**60 – 62 CHISHOLM RD AVALON BEACH
ALTERATIONS / ADDITIONS
STORMWATER MANAGEMENT DESIGN
Job No 201206**

In reference to DA 2022/1399, Councils letter dated 8 November 2022 and the Stormwater Management Plan (SWMP 18 10 2022) issued by this office.

Job No :
201206
Drawing No :
SW1

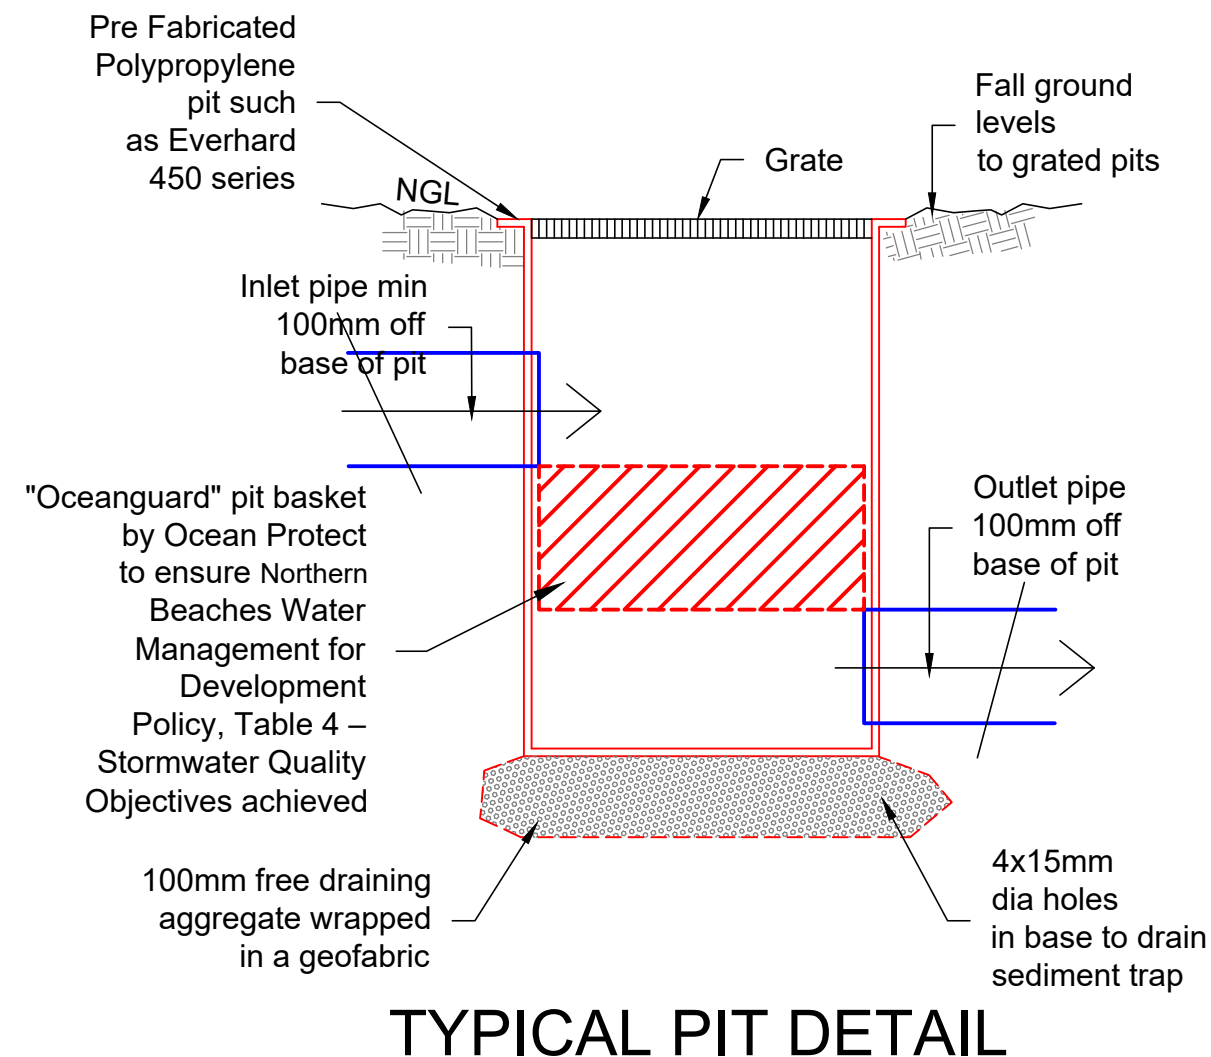
Development Engineer Referral -

- Calculations for pre and post development, details of the bypass flows and flows from the OSD as shown for all storms, as per DRAINS software analysis on SW3 of the plans issued by BCE.
- The rock gabion in the road reserve has been deleted.
- The discharge point is along the driveway to the dish drain in Chisholm Ave.
